PSE IRP Feedback Report
Webinar 1: Generic Resources Assumptions
May 28, 2020

2021 IRP Generic Resource Assumptions Workshop Feedback Report			
Feedback Form Date	Stakeholder	Comment	PSE Response
5/13/20	James Adcock	I am concerned that while I received an email "invite" to join the 2021 IRP process, when I tried to use the provided automated method of responding to that "invite" PSE's automated system instead logged an error message, rather than correctly "signing me up" for the IRP process. I then sent an email to PSE IRP leader Irena Netik, telling her about this problem, asking her to sign me up for the 2021 IRP, and asking her to acknowledge this email. She has not responded.	<p>An acknowledgement email was sent on 5/13/20 at 2:20 pm. A copy of the message is included below:</p> <p>From: Netik, Irena Sent: Wednesday, May 13, 2020 2:20 PM To: 'jimad@msn.com' <jimad@msn.com> Subject: RE: Welcome to PSE's 2021 IRP Process</p> <p>Hello Jim,</p> <p>Thank you for your continued involvement and interest in the 2021 IRP process. I am confirming that we did in fact receive your response to the poll in the MailChimp email indicating that you do want to be engaged in the 2021 IRP proces

Figure 1. U.S. Utility-Scale Solar PV Capacity and EIA Projections

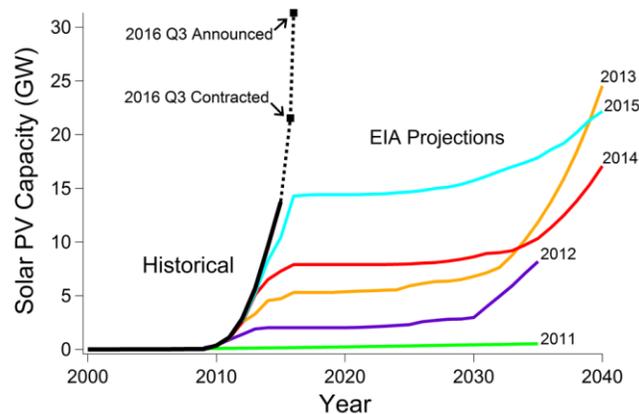
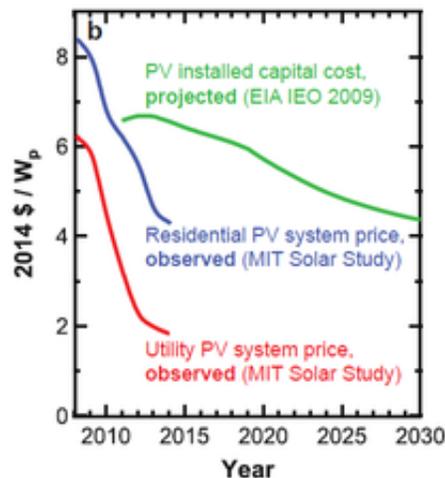
- **Owner's costs**
 - In the last IRP, PSE originally had 10% for RE and 30% for thermal, then ultimately used a blanket 30%.
 - We have requested from PSE a better understanding of what costs go into the owner's costs, and believe that those assumptions should be reflected in including owner's costs to the various resources.
- **EIA AEO learning curves**
 - AEO historically underestimates the installations of renewable energy capacity and therefore, the projected cost reductions of renewables.
 - We recommend using NREL's ATB instead of AEO.
 - A number of sources demonstrate EIA's poor track record projecting future deployment and costs:
 - [Clean Technica - AEO Wildly Misses the Mark, Again](#)

- [Clean Energy Action](#)
- [Zenmo: PV growth](#)
